## CIVIL CONSULTANTS MEMORANDUM

**SUBJECT: South Berwick Town Hall – Exterior Masonry Inspection**

**PROJECT: EXTERIOR REVIEW – TOWN HALL / COMMUNITY CENTER**

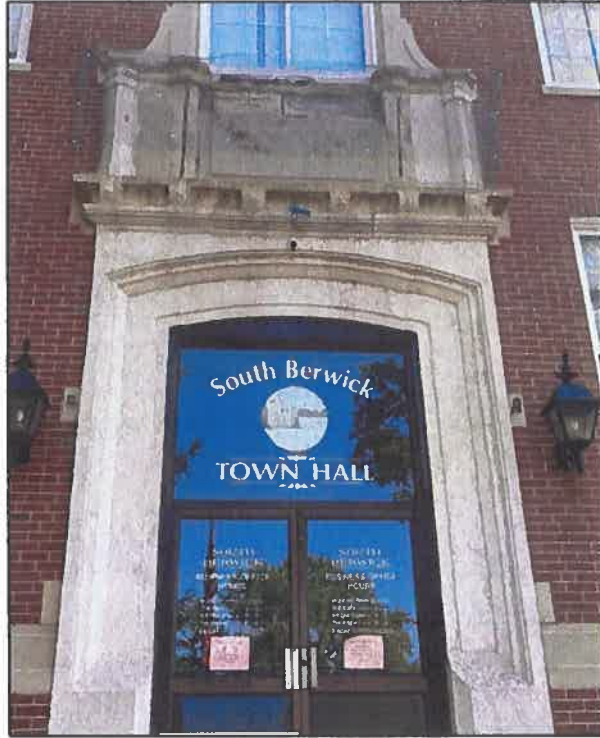
The repair to the main entry detail above main door will require more than a surface repair. The head sign detail has degraded to a condition that a majority of the face needs to be removed and replaced. If desired by the Town the existing detail can be recreated to have the pillars and signage above the door.

**A2**

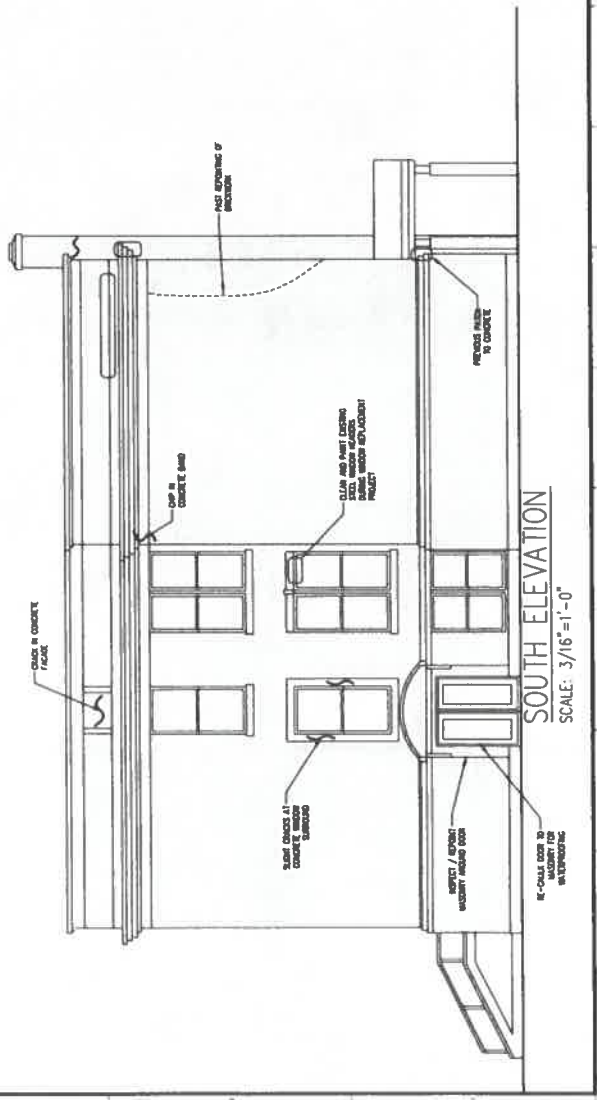
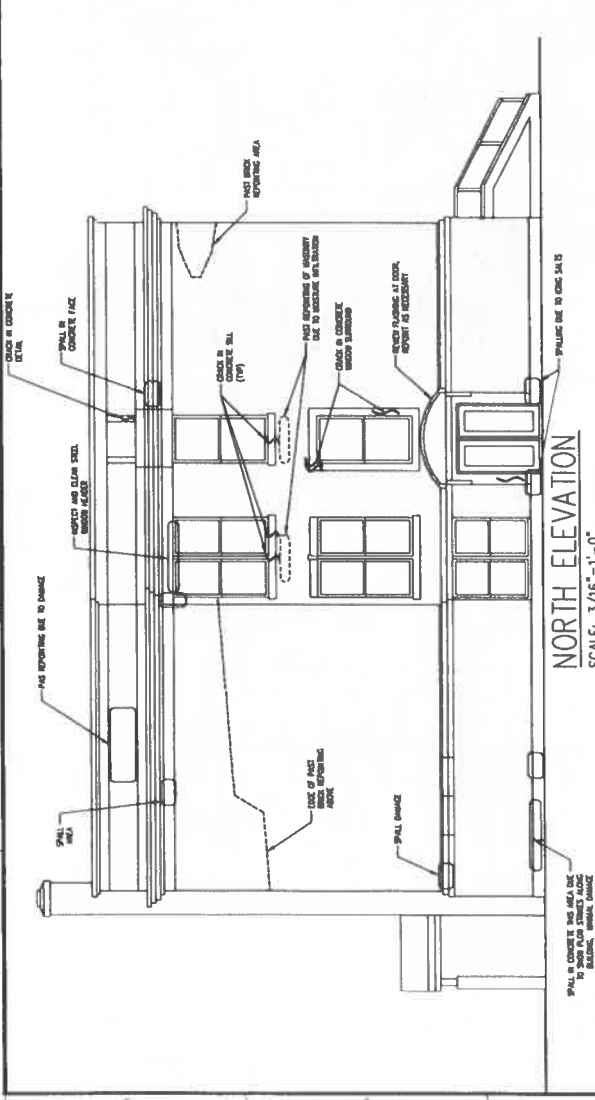
Most of the exterior brick work is in good condition, as areas have been repointed over the years to address observed issues. There are areas of the brick that will need to be addressed with repointing of the mortar beds. This will involve removal of existing mortar and placement of new. These areas are indicated on the attached elevation sheets.

I WALL SECTION

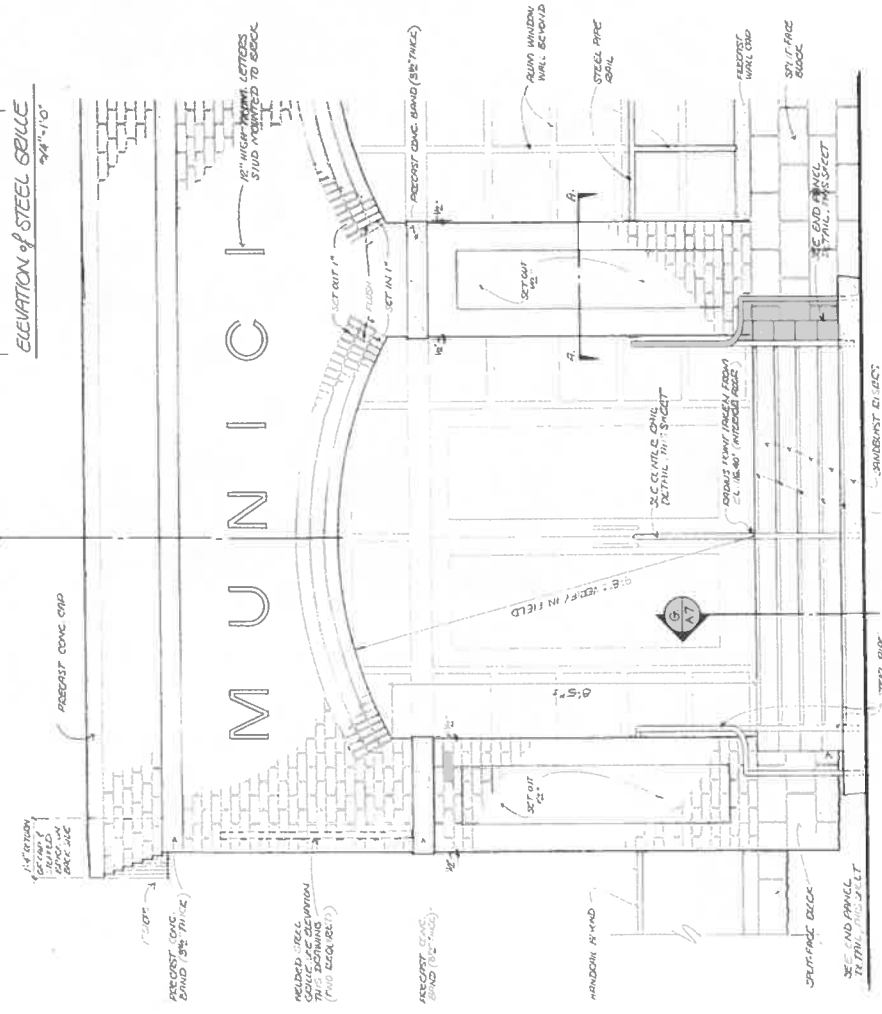
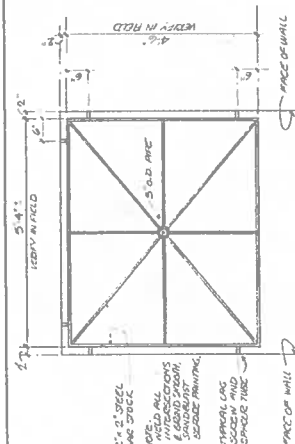
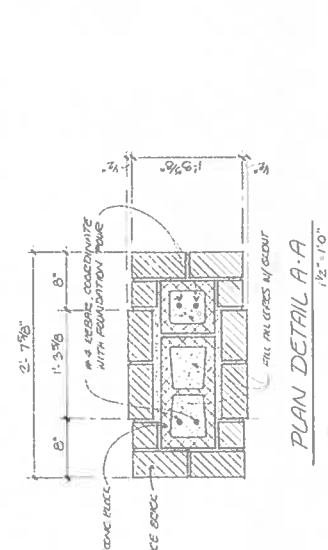
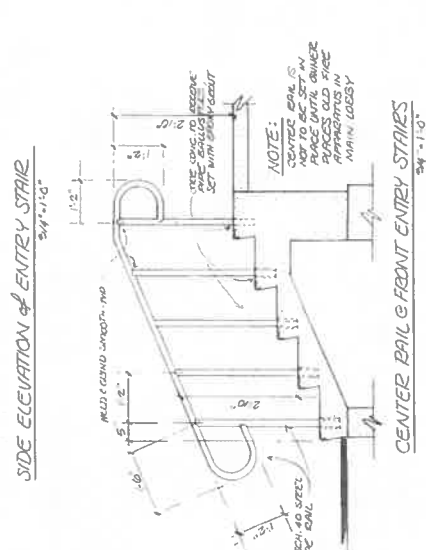
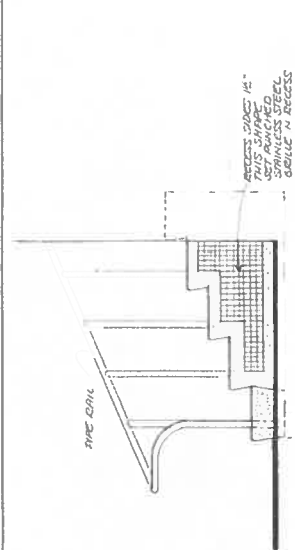
The building plans provided by Town Staff indicate that the brick

arch is supported by concrete block masonry. The block details were designed by the project architect during the renovation, not the project structural engineer. The details on the plan do not indicate how the arch of brick veneer is supported. It is our recommendation that some destructive testing and removal of finishes be completed to determine the damage to the existing masonry support. The work should be conducted by a mason with engineering oversight. Moisture is entering the brick veneer and causing the leaks and staining. The investigation will reveal if there is damage to the veneer supports. We recommend that this be completed sooner rather than later.
